CHANGES FOR SECTION 96 APPROVAL

STAGE 5 - CLUB EXTENSION

3D VIEW - 12 METRES HEIGHT
PLANE OVERLAY

SCALE: As indicated @ B1			DATE: NOVEMBER 2017	
DRAWN BY: MC	CHECKED BY: DOC	PROJECT NO: 2341.06	DRAWING NO: DA-0004	ISSUE: 2
CAD FILE:

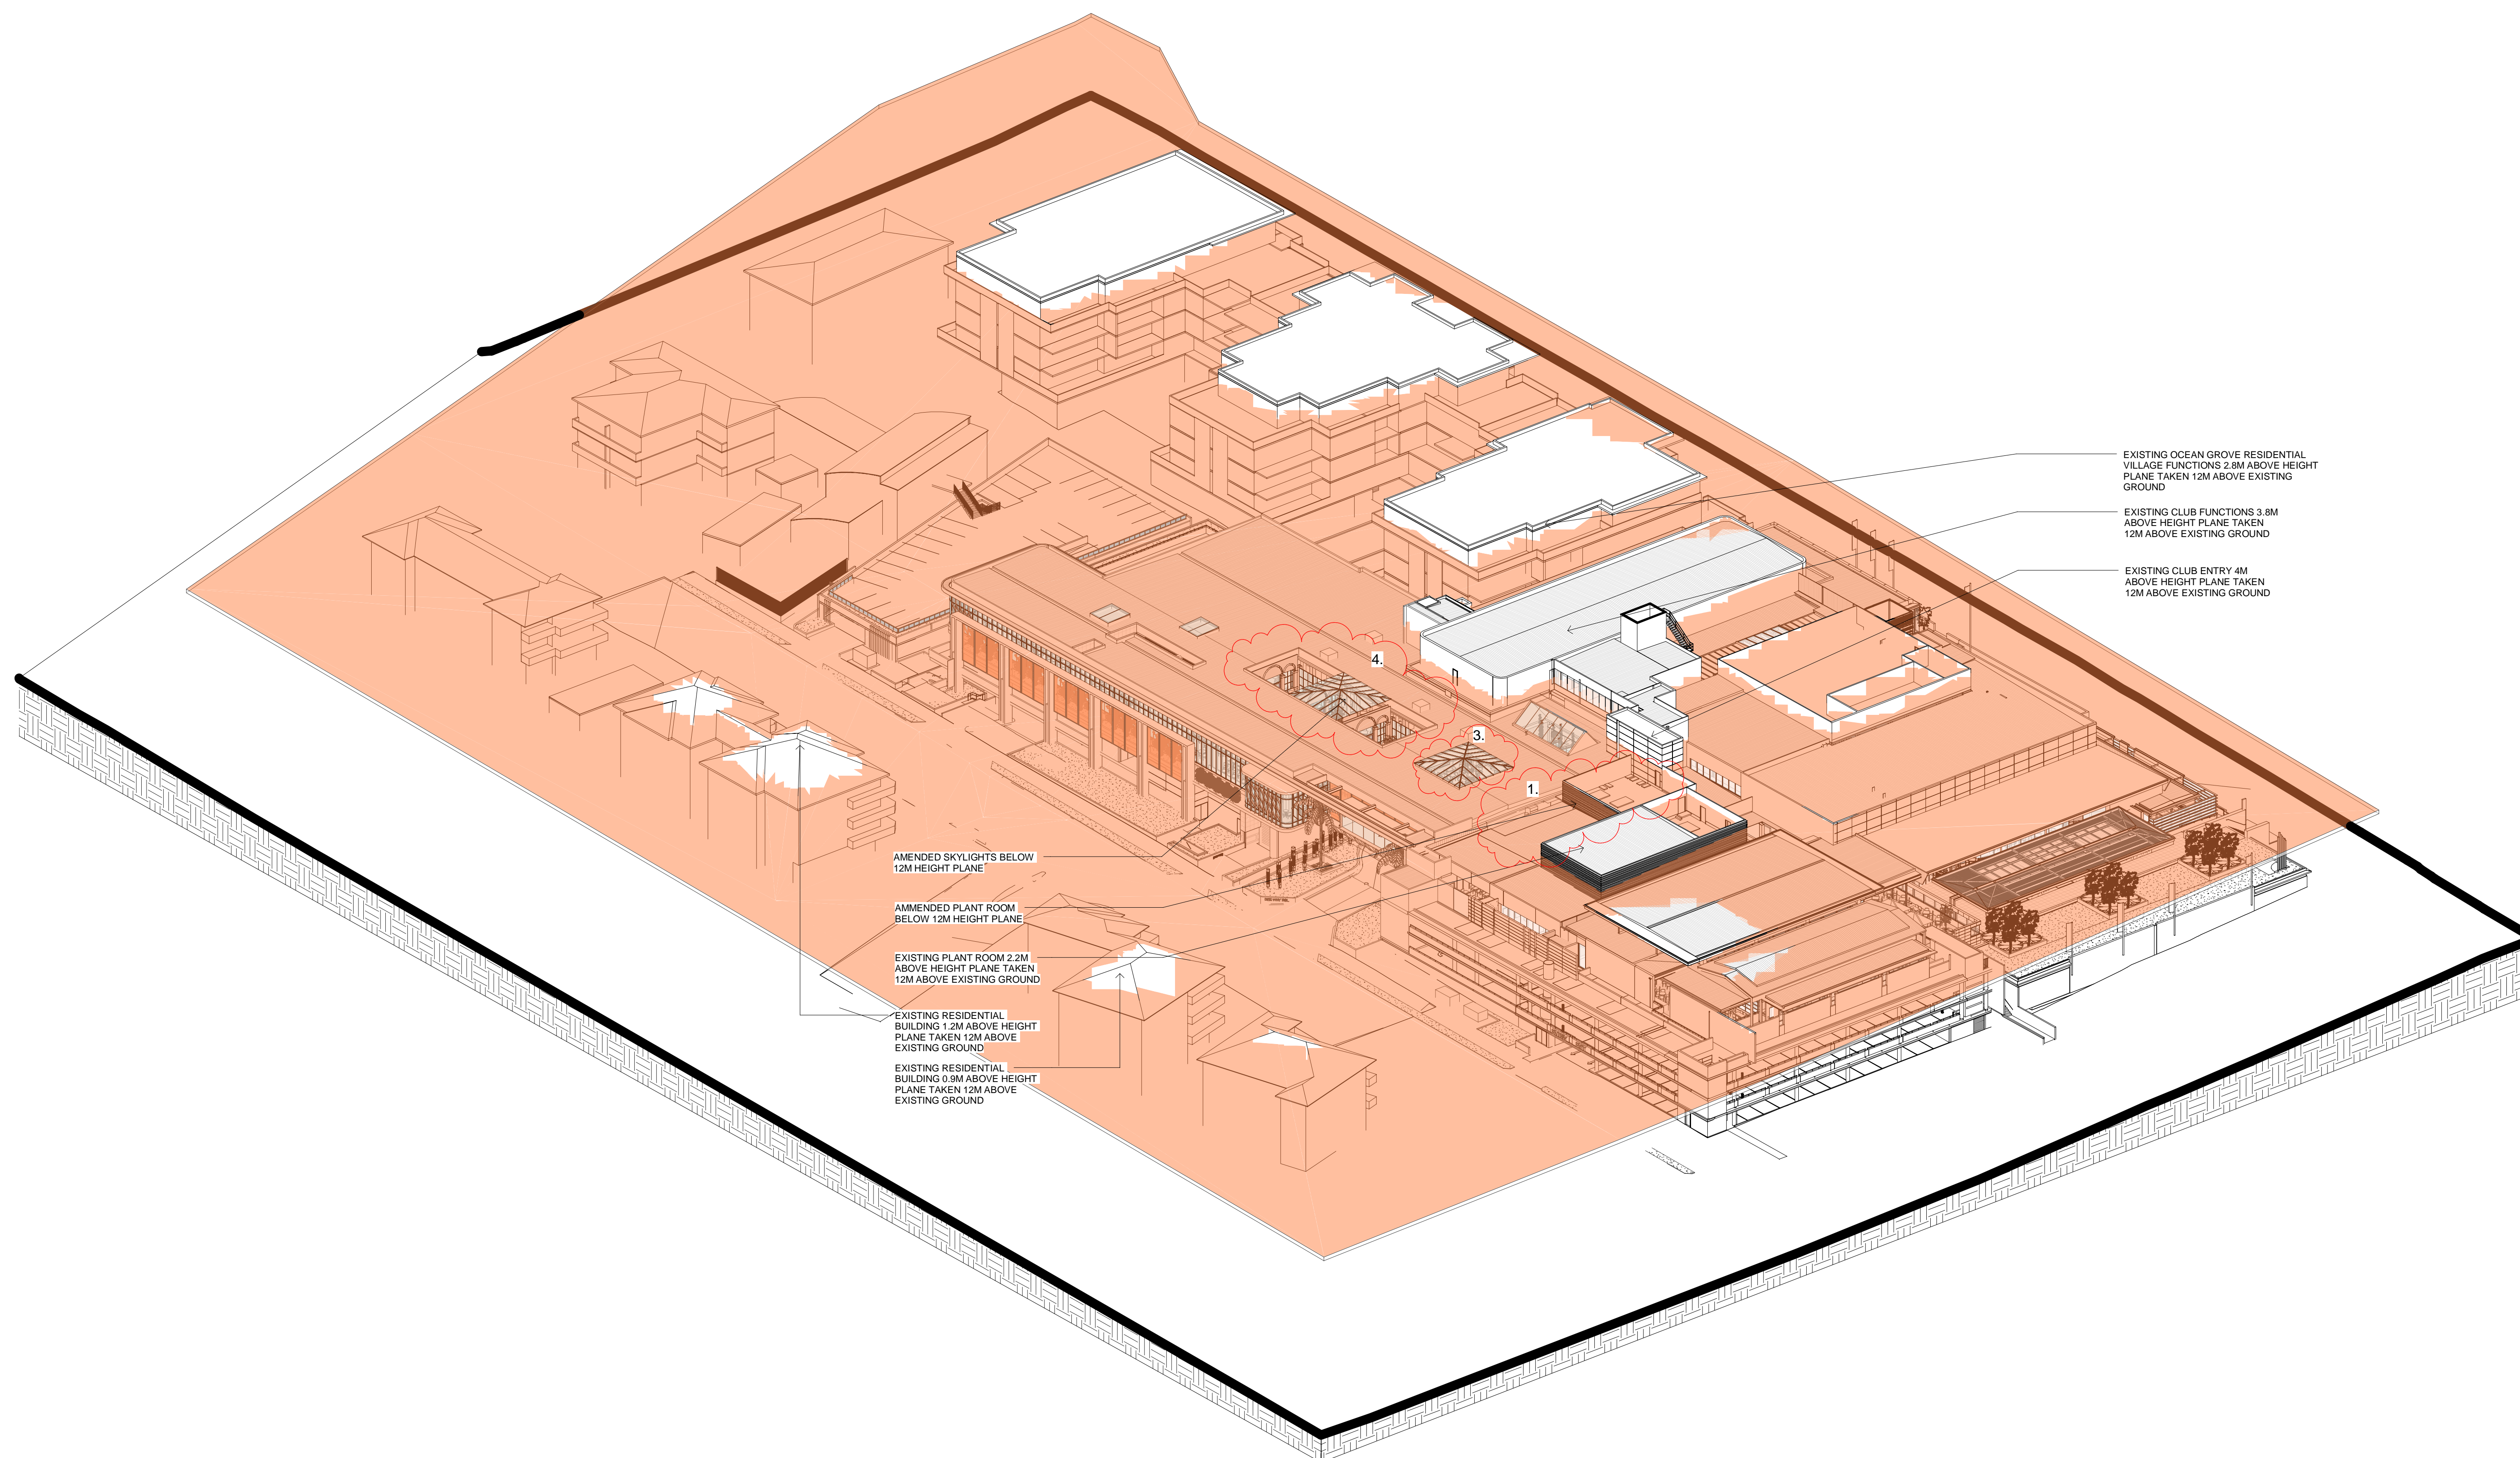
1. SMALLER PLANTROOM
2. MODIFIED ROOF OPENING ABOVE MAIN ENTRANCE
3. MODIFIED CENTRAL SKYLIGHT (REDUCED HEIGHT MODIFIED SHAPE)
4. MODIFIED COURTYARD : 2 OPEN COURTYARDS AND ONE SKYLIGHT COVERED AREA INSTEAD OF ONE COURTYARD GLASS ROOF WITH REDUCED HEIGHT

5. MODIFIED ROOF OPENING FOR SMOKING TERRACE
6. REDUCED NUMBER OF ROOF SKYLIGHTS ABOVE ASIAN RESTAURANT - 2 INSTEAD OF 5
7. NO ROOF ABOVE EXIT STAIR
8. NEW MEMORIAL WATER FEATURE AND POLES IN THE NORTH COCHERE AREA AS PER LANDSCAPE PLAN

9. MODIFIED FACADE AREA DUE TO MECHANICAL RISER NO LONGER REQUIRED AND LOCATION CHANGE FOR VENTILATION PATH
10. NEW EGRESS PATHS FROM NEW CARPARK LEVEL 1 AND EXISTING SOUTHERN CARPARK

11. NEW EGRESS DOOR AND REMOVED LOUVRES (NO LONGER REQUIRED FOR NEW VENTILATION)
12. MODIFIED CURTAIN WALL FACADE FINS
13. REDUCED HEIGHT FOR FACADE CONCRETE BLIND

14. NEW PLANTER ON LEVEL 2 SOUTH AND WEST FACADES
15. BLADES REMOVED FROM BACK WALL
16. RELOCATED ELECTRICAL SUBSTATION/ NEW FULL HEIGHT WALL ON EXISTING SOUTHERN CARPARK FACADE

17. MEDIAN STRIP ADDED AT ENTRY TO PROVIDE FULL REFUGE AND ENSURE WIDTH OF ENTRY/EXIT IS LESS THAN 8M AS PER DA CONDITIONS
18. BUILDING ENLARGED BY 425mm TOWARDS THE COURTYARD

19. RELOCATED STORMWATER OVERTFLOW PATH
